Product Equality Declaration

We, SIMCom Wireless Solutions Limited, declare on our sole responsibility for the products' change on A7671G (initial) and A7670G (variant) have the same electrical characteristics, but the differences between them is the GNSS main chip scheme and the number of solder pads at the bottom of the PCB., the other RF specifications are same and conducted performance are same setting. Details as below:

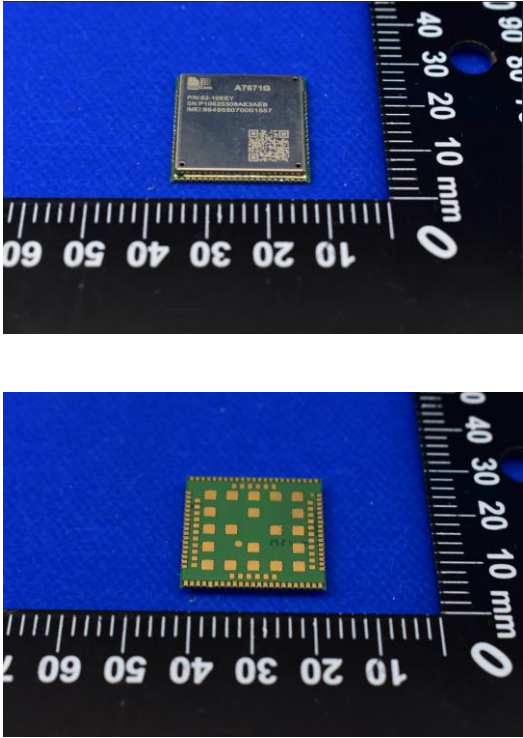
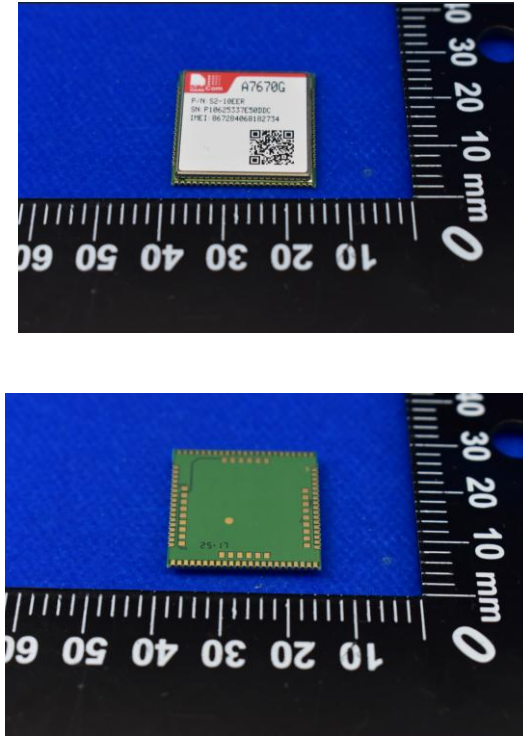
Item	Initial	Variant
Model	A7671G	A7670G
FCC ID	2AJYU-8BM0001	2AJYU-8BM0002
LTE Chipset	ASR1605S	ASR1605S
LTE Bands	LTE Cat 1bis: B2/4/5/7/12/13/18/19/25/26/38/40/41/66/71,	LTE Cat 1bis: B2/4/5/7/12/13/18/19/25/26/38/40/41/66/71,
GNSS Chipset	AG3352BV/A	CC1161W
GNSS Spec	GPS/BDS/Galileo/GLONASS/SBAS: 1559-1610MHz	GPS/BDS/Galileo/GLONASS/QZSS: 1559-1610MHz
Photos

HW Description			
HW Infor.	PCB	Same for WWAN.	
	PCBA	the differences between them is the GNSS main chip scheme and the number of solder pads at the bottom of the PCB.	
SW description			
SW Same	Modem /RF	All WWAN RF conducted performance are same setting	
SW Diff.	GNSS	A7671G supports GPS/BDS/Galileo/GLONASS/SBAS	A7671G supports GPS/BDS/Galileo/GLONASS/QZSS
